**DEVELOPMENT VARIANCE PERMIT**

PERMIT NUMBER: **VP-604**

Title: Development Variance Permit Application No. VP-604

TO: Director of Development Services  
 DATE: 1 October 2024  
 PREPARED BY: Mustafa Zakreet, Engineering Assistant  
 SUBJECT: **VARIANCE PERMIT APPLICATION FILE NO. VP- 604**  
 OWNER: **Broadview Evangelical Free Church, and Shuswap Christian Education Society, - 350 – 30 Street NE, Salmon Arm, BC V1E 1J2**

Site Plans  
Drawing No. A1.1

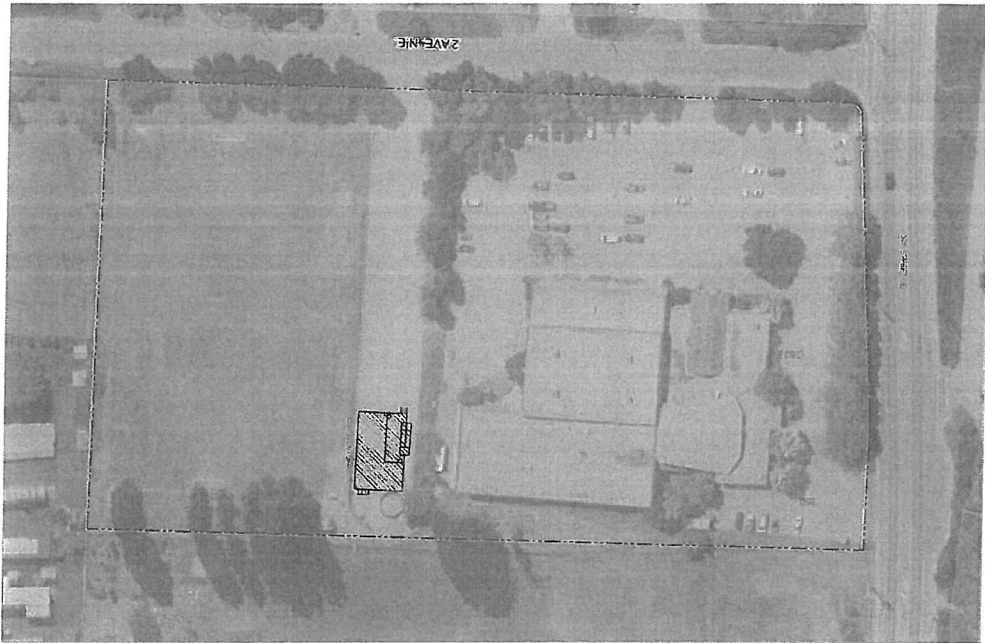
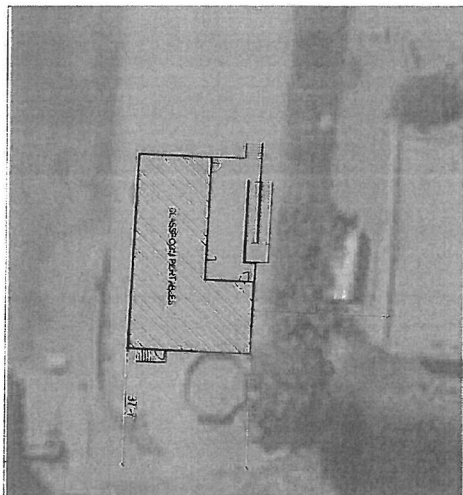
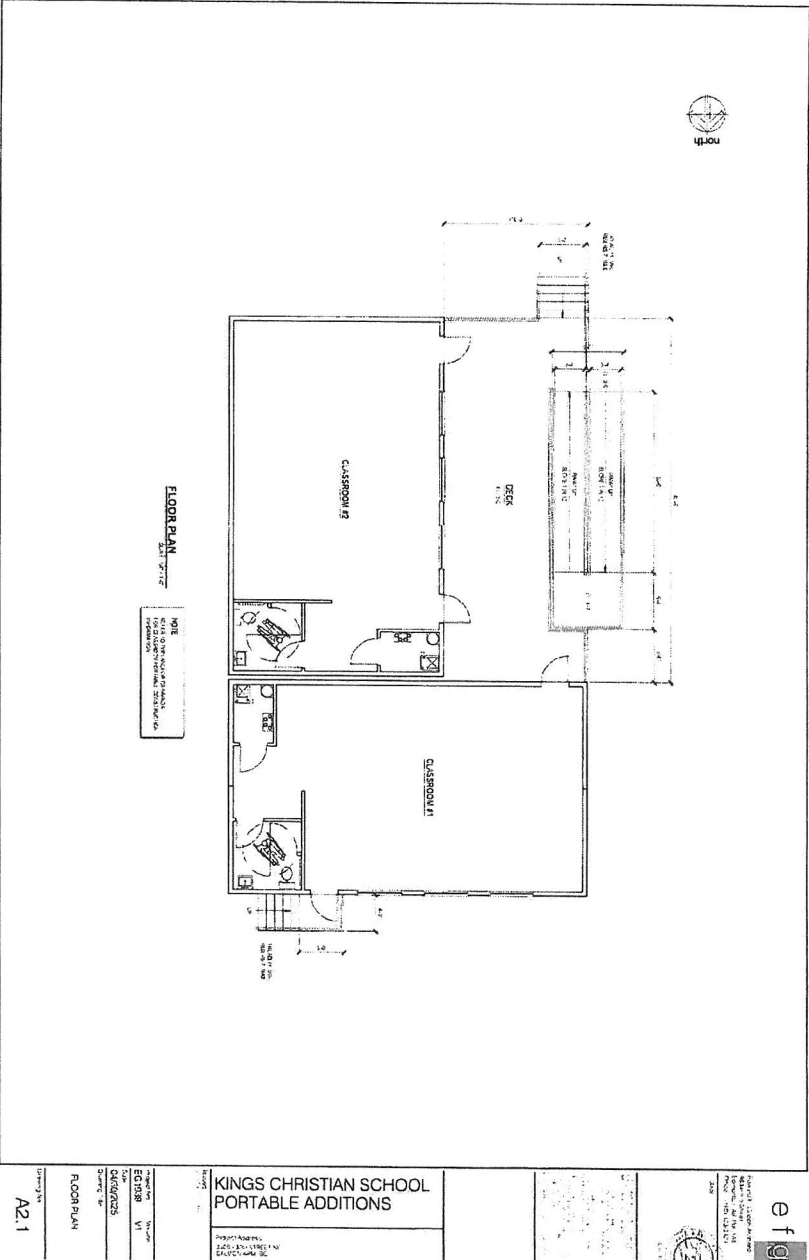
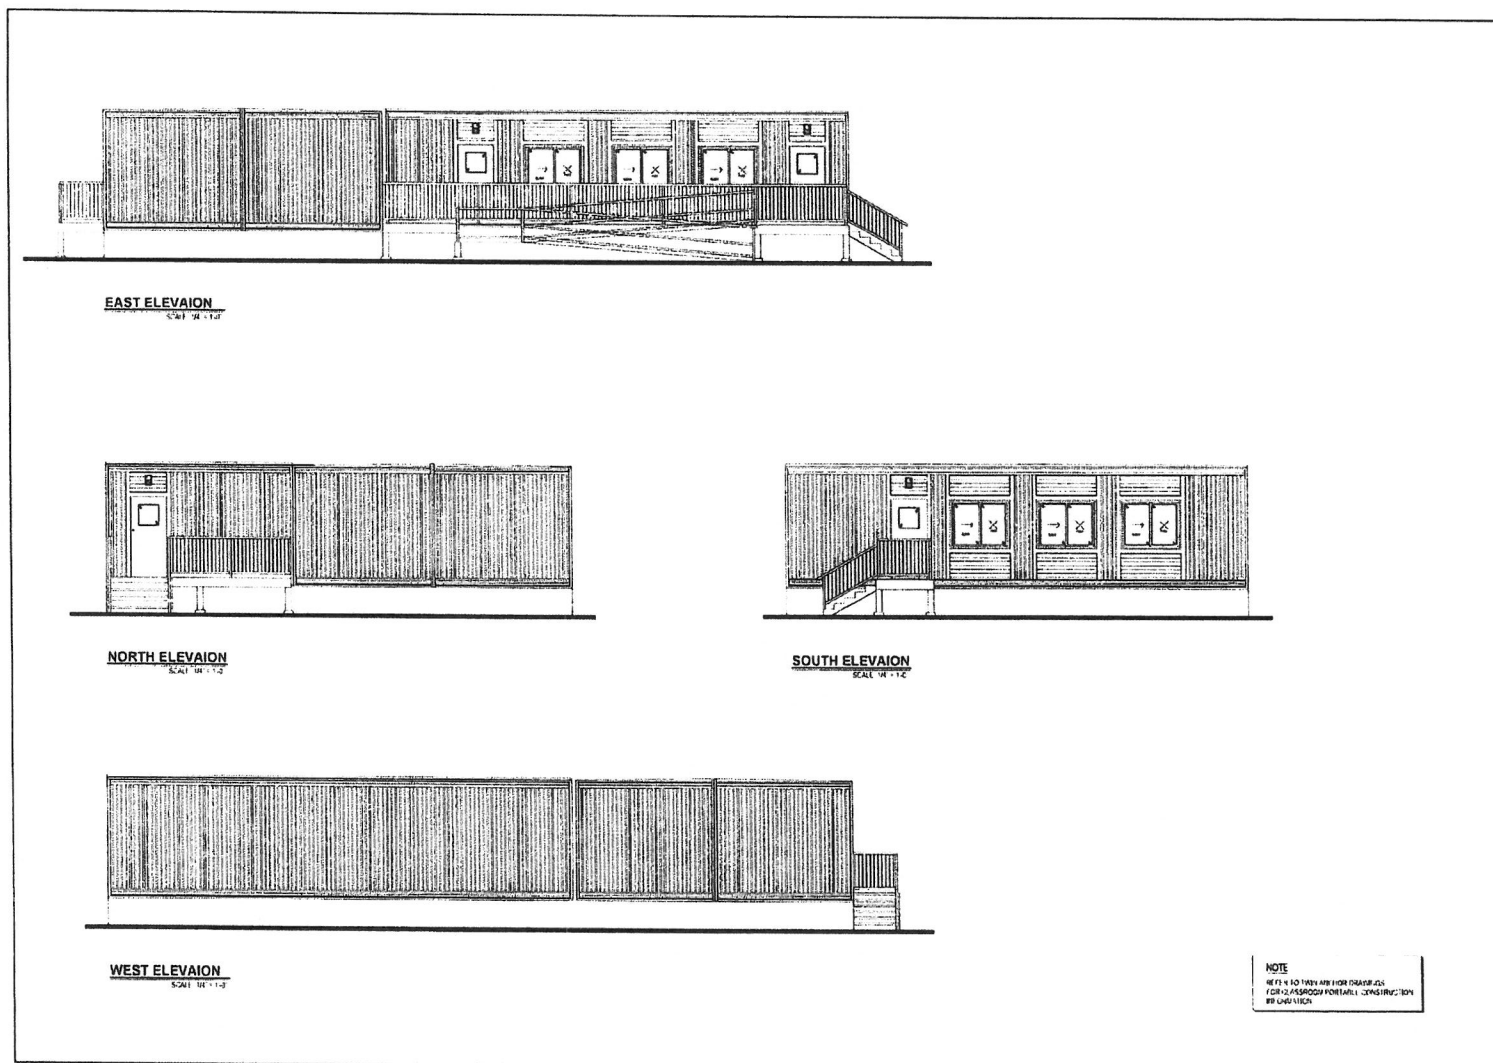
**PORTAL SEPARATION EAST WALL OF EXISTING SCHOOL**  
TABLE 1.1.1.1.1  
DISTANCE FROM EXISTING WALL TO NEW WALL: 10.0 FT  
DISTANCE FROM EXISTING WALL TO NEW WALL: 10.0 FT  
DISTANCE FROM EXISTING WALL TO NEW WALL: 10.0 FT  
DISTANCE FROM EXISTING WALL TO NEW WALL: 10.0 FT  
DISTANCE FROM EXISTING WALL TO NEW WALL: 10.0 FT

**PORTAL SEPARATION WEST WALL OF PORTABLES**  
TABLE 1.1.1.1.2  
DISTANCE FROM EXISTING WALL TO NEW WALL: 10.0 FT  
DISTANCE FROM EXISTING WALL TO NEW WALL: 10.0 FT  
DISTANCE FROM EXISTING WALL TO NEW WALL: 10.0 FT  
DISTANCE FROM EXISTING WALL TO NEW WALL: 10.0 FT  
DISTANCE FROM EXISTING WALL TO NEW WALL: 10.0 FT

20m R/W Urban Local Road  
Cross-Section

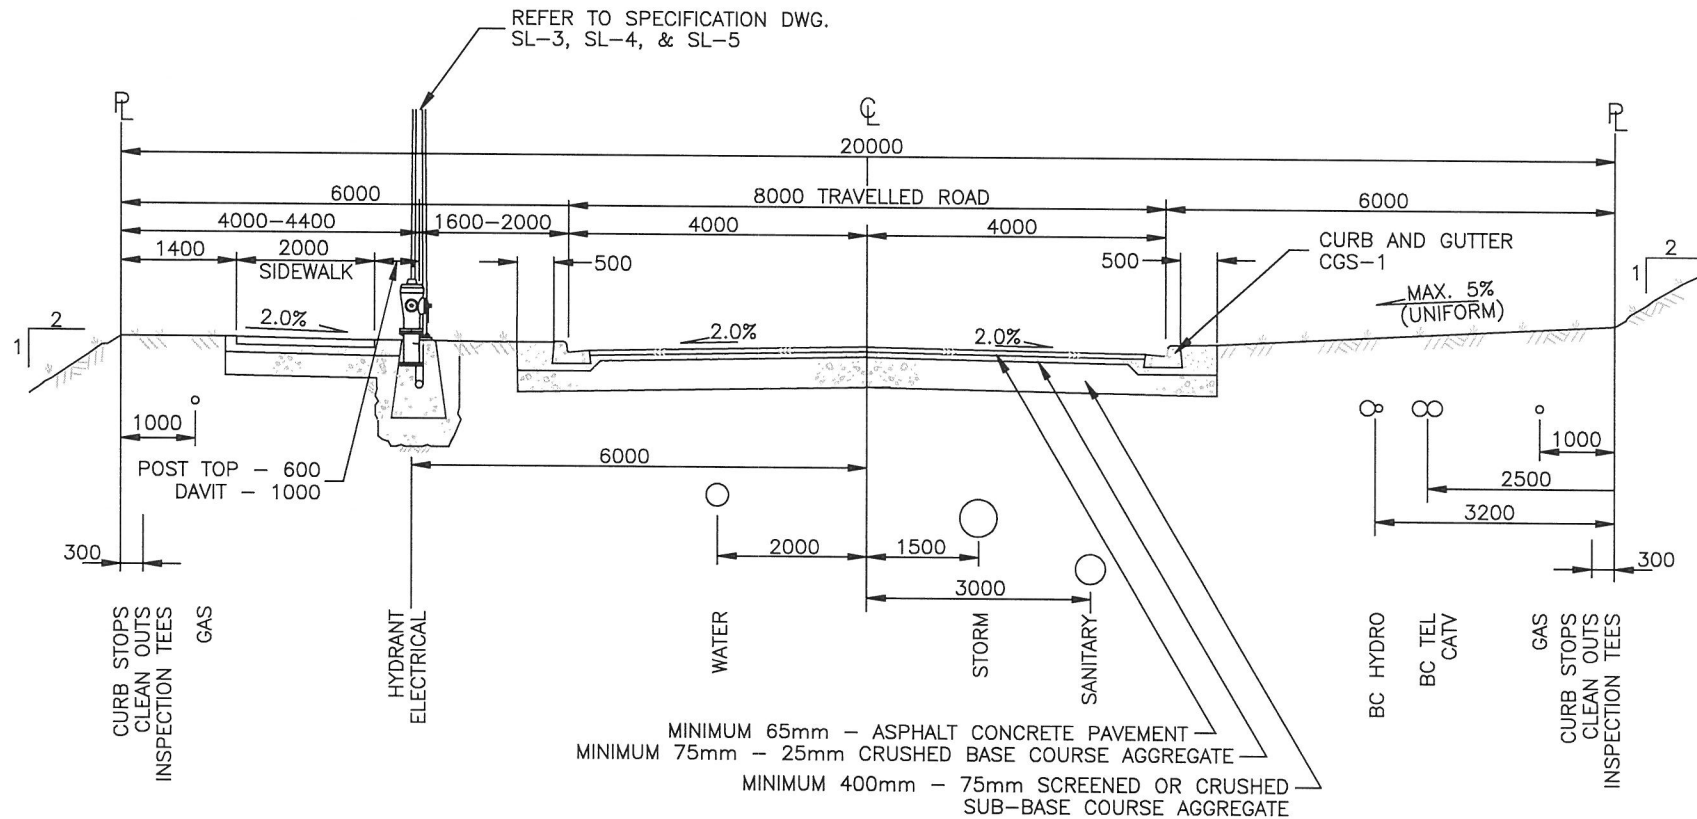
Subdivision and Development Servicing Bylaw: the SDS Bylaw details the required frontage improvements applicable along 30 Street NE (RD-4) and 2 Avenue NE (RD-2).
